MONTGOMERY COUNTY PLANNING DEPARTMENT

MEMORANDUM

SUBJECT: Worksession No. 1: Draft Germantown Urban Design Guidelines
Sector Plan for the Germantown Employment Area

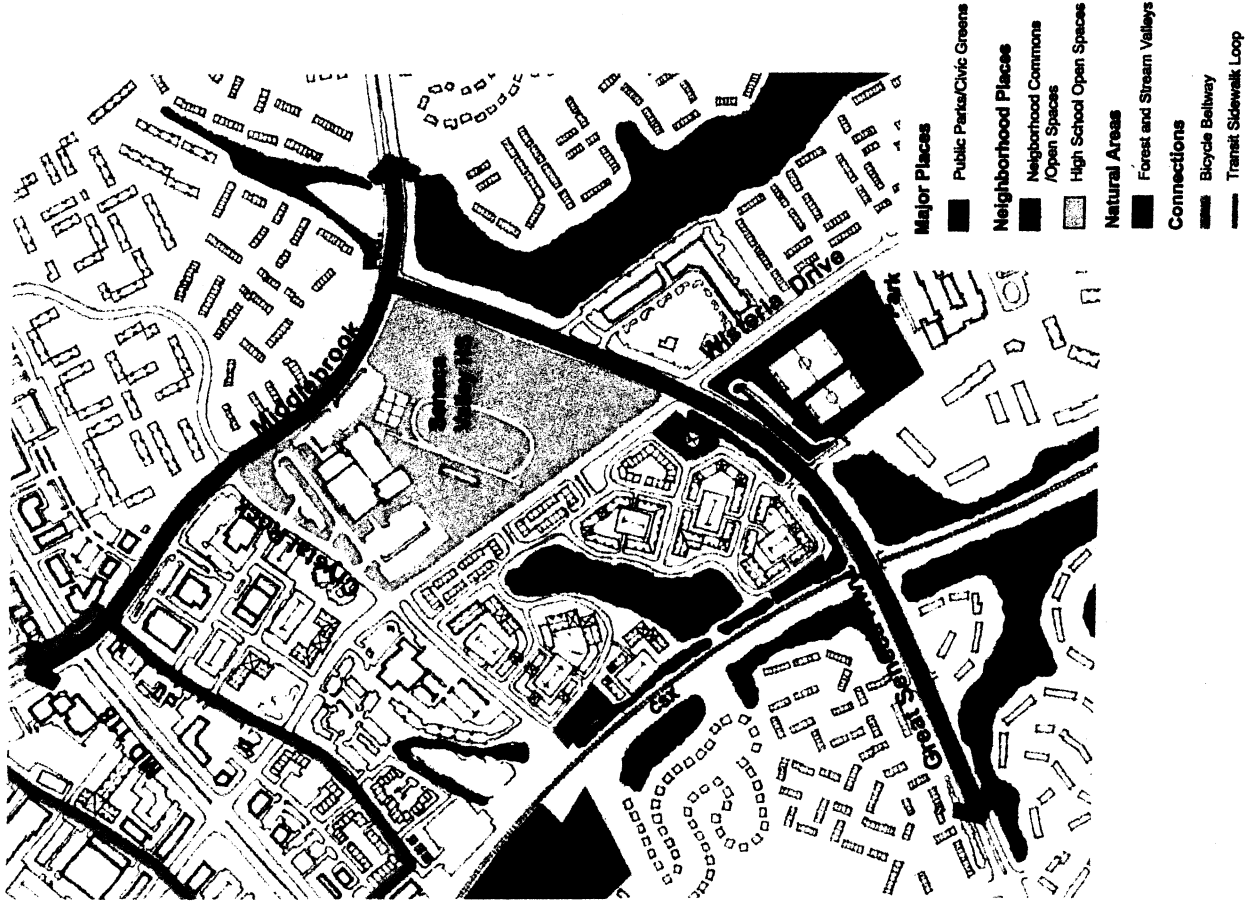
Comment/Suggested Change: We believe there is a formatting error in the Open Spaces section of the Gateway District in the October 2009 Draft Guidelines where the last two bullet points were incorrectly moved under the heading of Rolling Hills Property, making them appear applicable to the Rolling Hills Property (see Exhibit A). The last two bullet points reference streets which are not adjacent to our property and therefore, do not apply to the Rolling Hills Property. These bullet points were previously shown in the April 2009

- Agree that recreation facilities should be decided during the review of a Site Plan, and the guidelines should list desirable facilities. Revise text to state: “provide facilities such as....” instead of specifying. Agree that “community center” can be revised to “community meeting rooms”. (March Draft, Rolling Hills, p. 52)
